PROJECT:	Wells County Public Library Renovations	SUPPLEMENTAL INFORMATION (SI) NUMBER:	71R1
		DATE OF ISSUE:	7/7/2020
OWNER:	WCPL	CONTRACT FOR:	General Construction
		CONTRACT DATED:	12/9/2019
TO CONTRACTOR:	CME Corporation	ARCHITECT'S PROJECT NUMBER:	19067

SUMMARY: REPLACEMENT LIGHTING AND SWITCHING, PARLOR ROOM CEILING
DESCRIPTION:

ENGINEER'S SUPPLEMENTAL INSTRUCTIONS #16 - Revision 1
Wells County Public Library Renovation
200 West Washington Street
Bluffton, IN 46714
Commission No. 192414

SECOND FLOOR ELECTRICAL LIGHTING PLAN

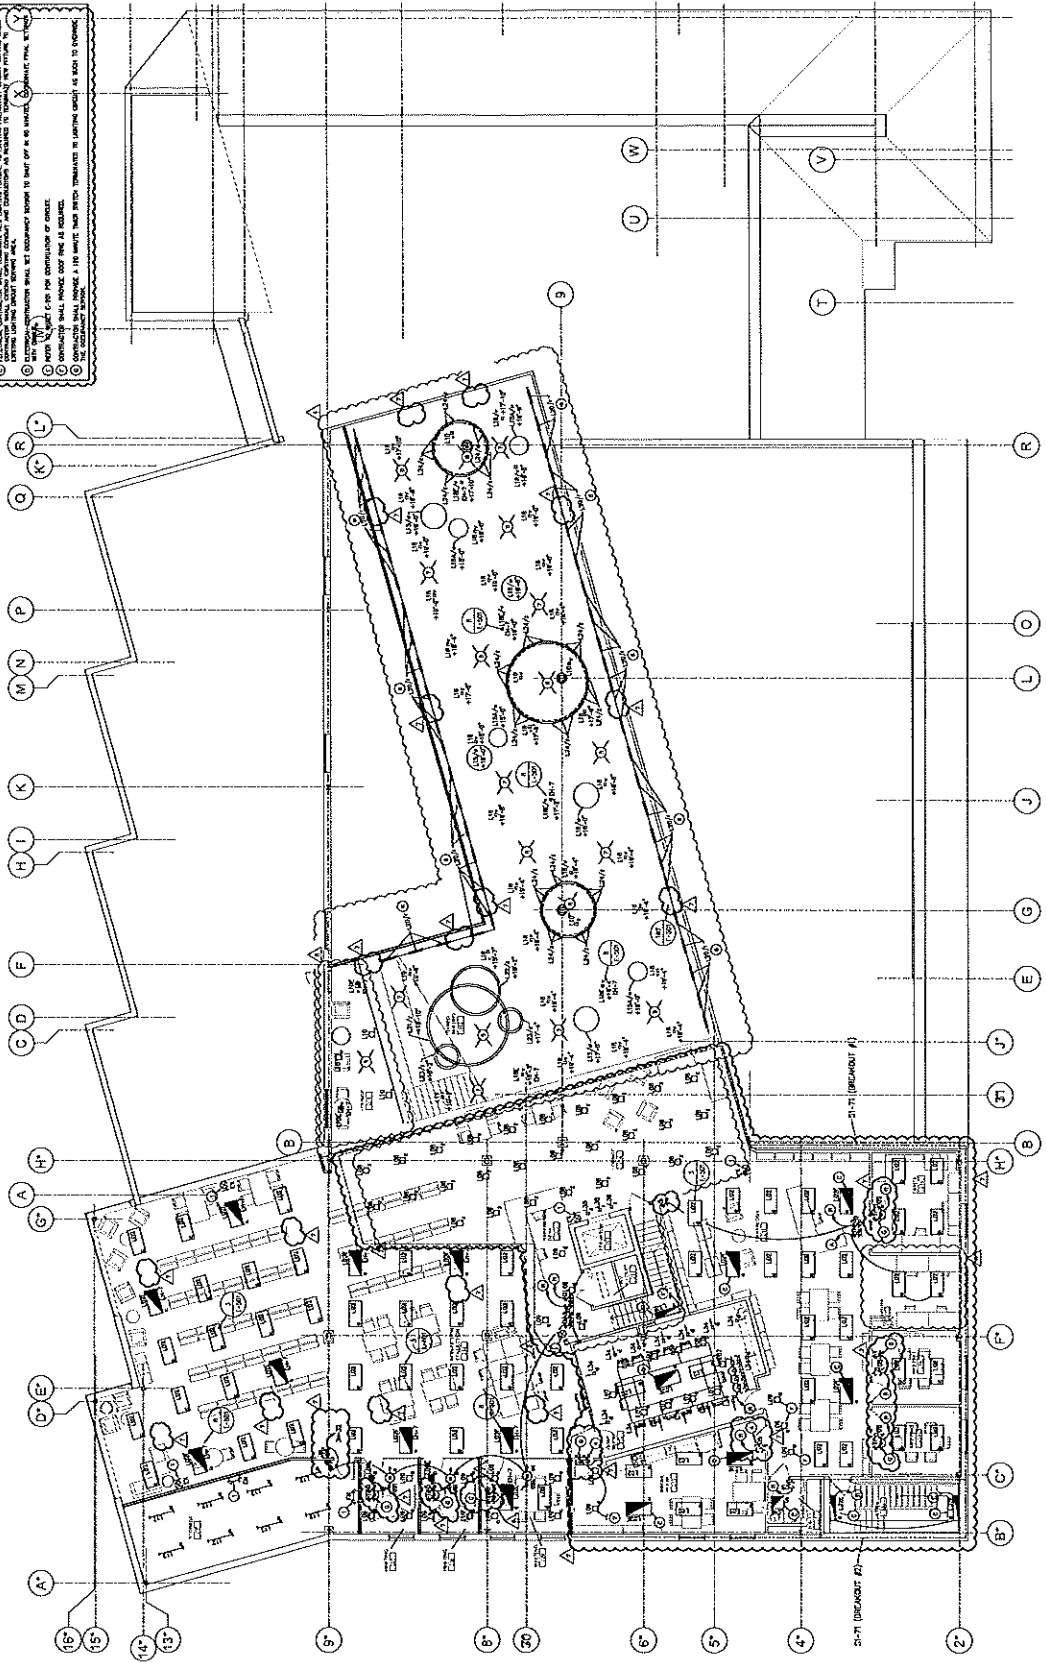
- Breakout Cost 01:** Provide cost to remove existing lighting and install new lighting in the areas marked in red per the attached documents. **PCO #063: \$71,510.90 + GENERAL CONDITIONS**
- Breakout Cost 02:** Provide cost to remove existing lighting and install new lighting in the areas marked in blue per the attached documents. **PCO #064: \$8,512.71 + GENERAL CONDITIONS**
- Breakout Cost 03:** Provide cost to install new manual override switches / added switches per the attached documents.
- Breakout Cost 04:** Provide cost to install new receptacle at TEEN & AV OFFICE 132 West Wall at CD Cleaning Machine.

BREAKOUT COST 2 - NEW LIGHTING

FIRST FLOOR ELECTRICAL LIGHTING PLAN

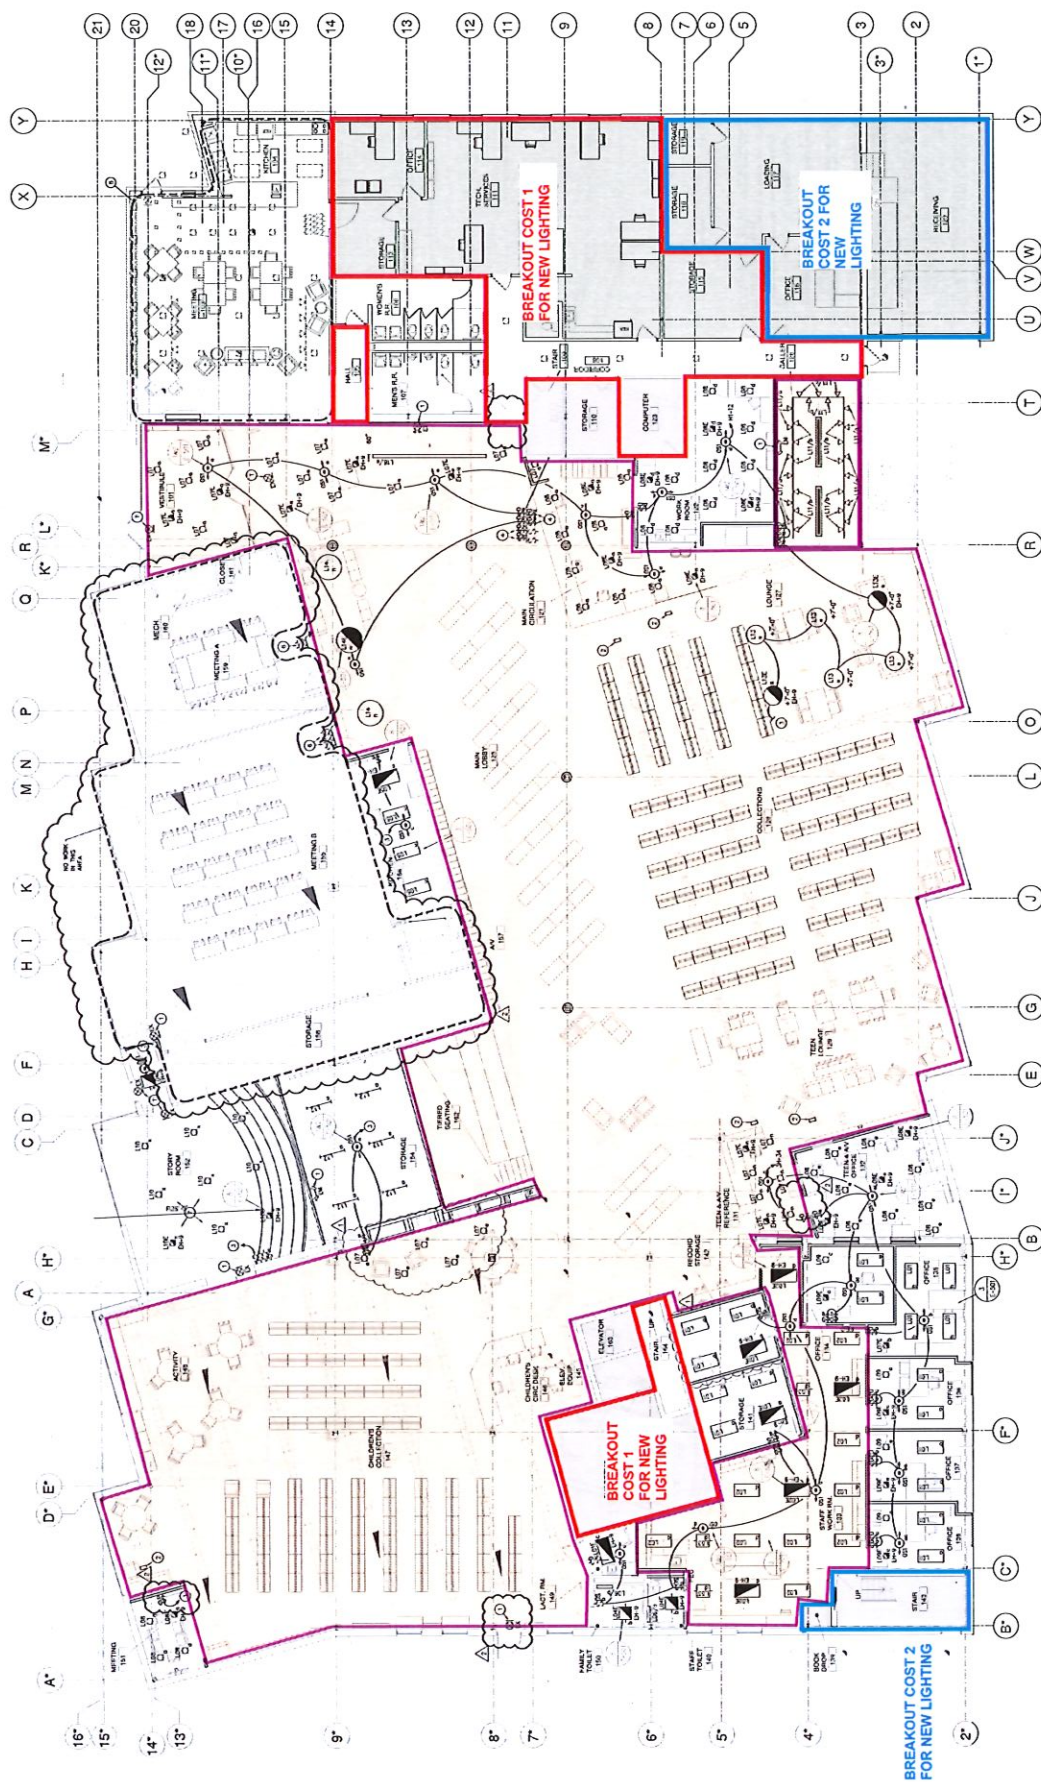
- Item No. 1:** On sheet E-001, the electrical contractor shall state the cost for additional work shown on the attached supplemental information drawing 2414E001-06-25-2020. Contractor shall refer to the architectural drawings for multiple cost breakout areas and additional scope.

- Item No. 3:** On sheet E-201, the electrical contractor shall state the cost for additional work shown on the attached supplemental information drawing 2414E201-06-25-2020. Additional lighting control switches were added in the following rooms: north and south sided of Children Desk #146 elevator, and east Staff RM #133. Contractor shall refer to the architectural drawings for multiple cost breakout areas and additional scope.

SECOND FLOOR ELECTRICAL LIGHTING PLAN

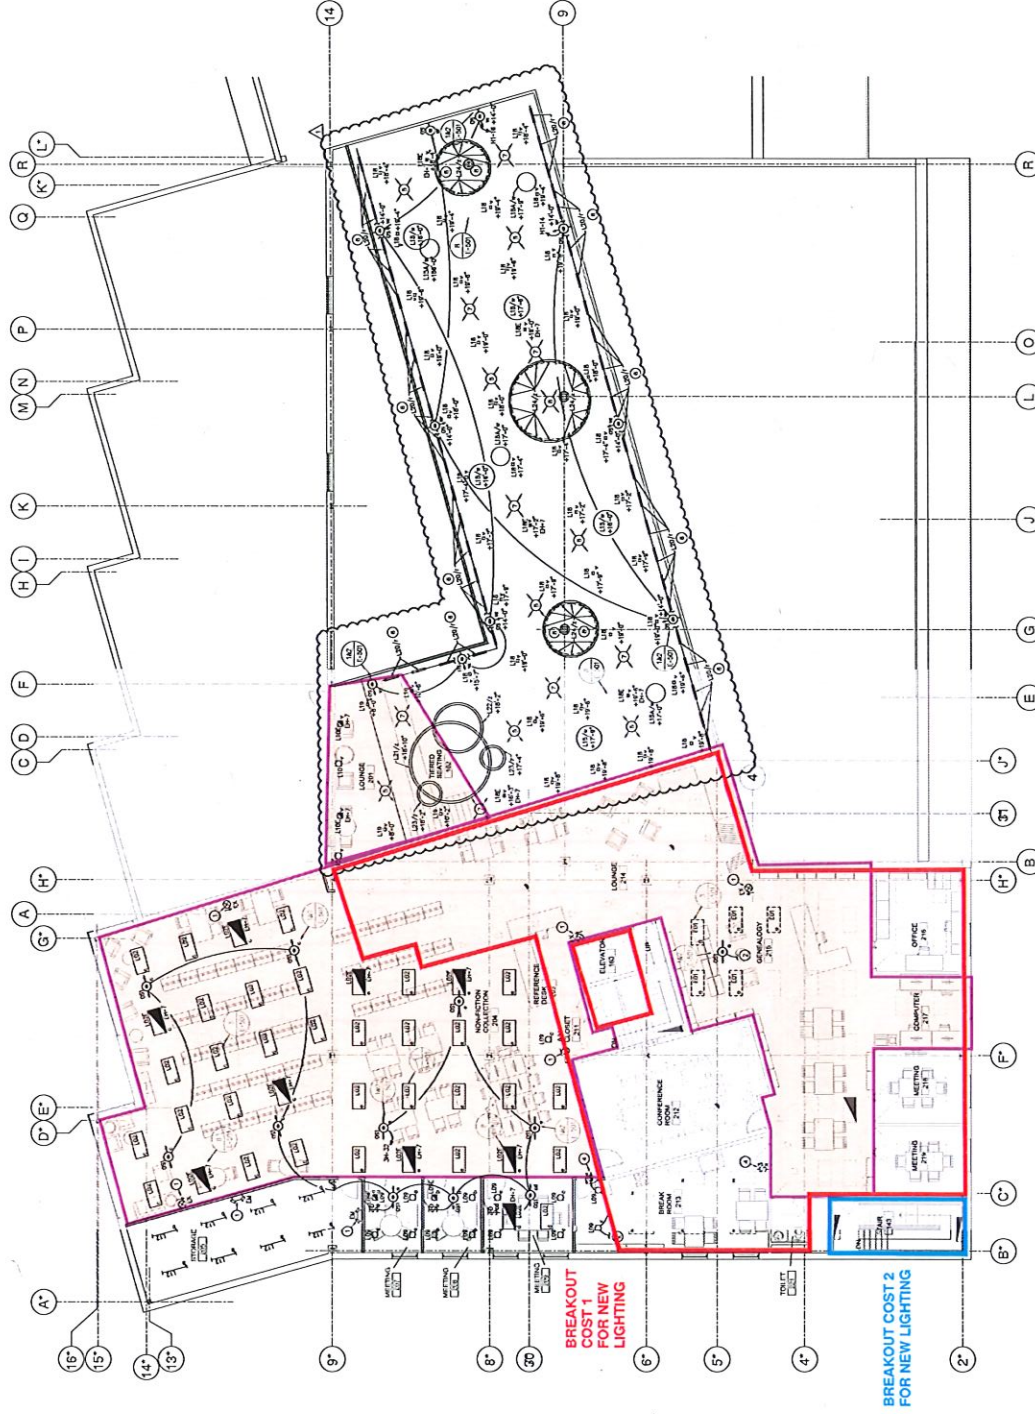
BREAKOUT COST 1 - NEW LIGHTING

BREAKOUT COST 2 - NEW LIGHTING

BREAKOUT COST 3 - OCCUPANCY SENSOR OVERRIDE SWITCHING:
REFER TO ELECTRICAL FOR EXACT SWITCH MODIFICATION LOCATIONS
AND SCOPE. THE SHADED AREAS SHOW THE AREAS OF THE PLAN THAT ARE
NOT REQUIRED TO BE ON OCCUPANCY SENSOR SWITCHES. THE OWNER
PREFERS TO ELIMINATE ALL OCCUPANCY SENSOR SWITCHES IN THE BUILDING
WHERE PERMITTED BY CODE AND INSTALL NEW MANUAL OVERRIDE SWITCHES.

PARLOR ROOM CAN LIGHTING PLACEMENT DIAGRAM

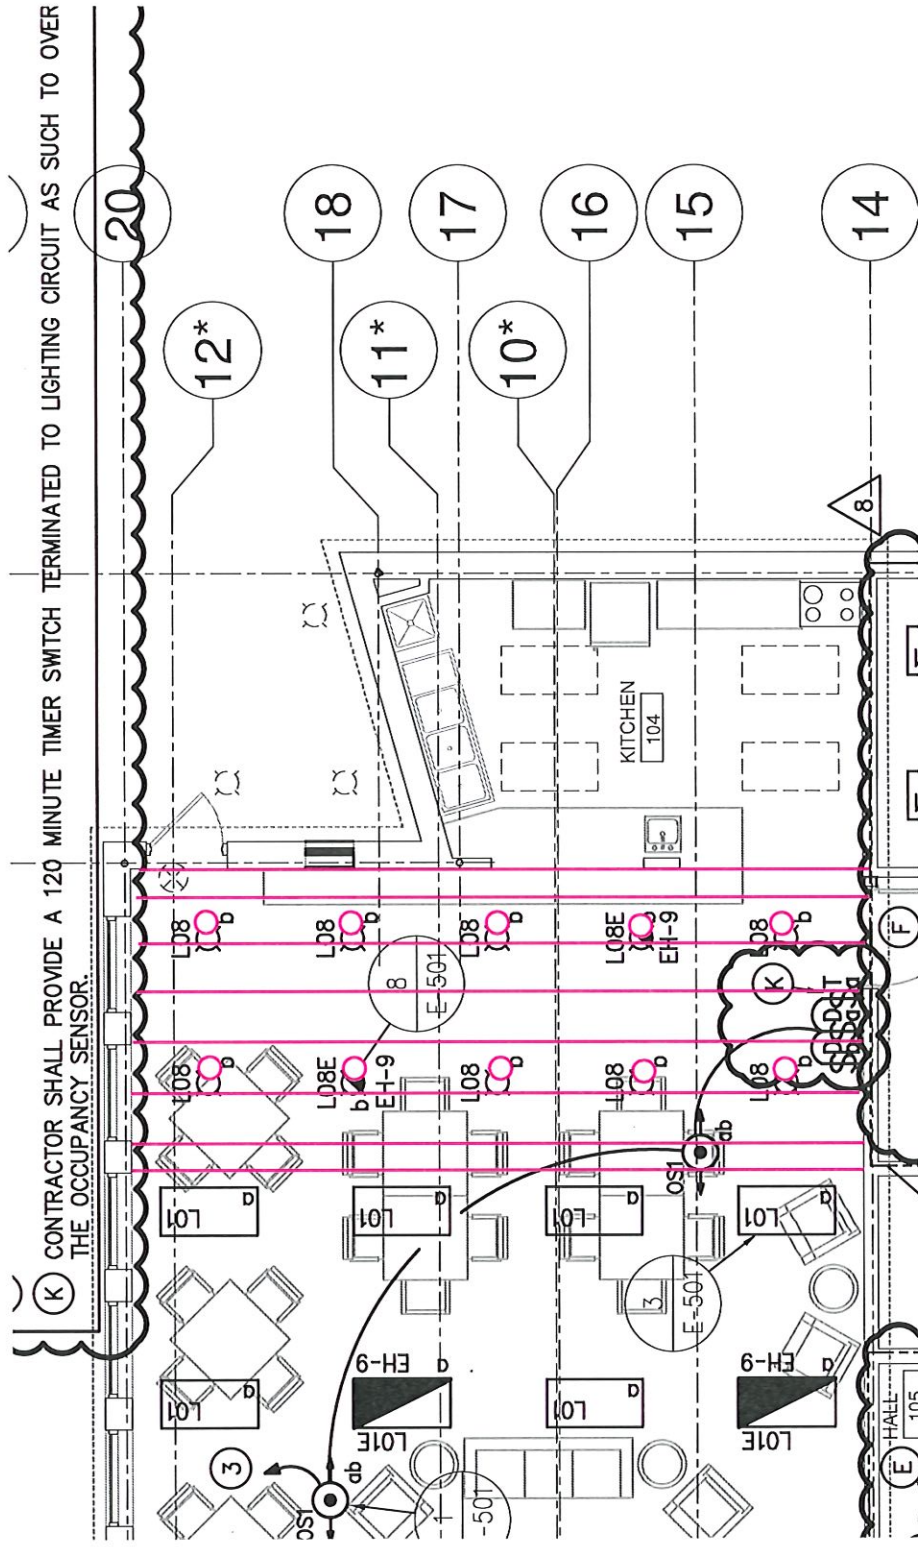
No-Cost Item: Please see attached revised electrical lighting plans / sheets for revised lighting layout due to the removal of the bulkhead at MEETING 103 ceiling. Please see attached can light configuration diagram for this area to locate can lights with existing bulkhead framing to remain as requested by contractor.

EXISTING BULKHEAD FRAMING
 REVISED CAN LIGHT LOCATION
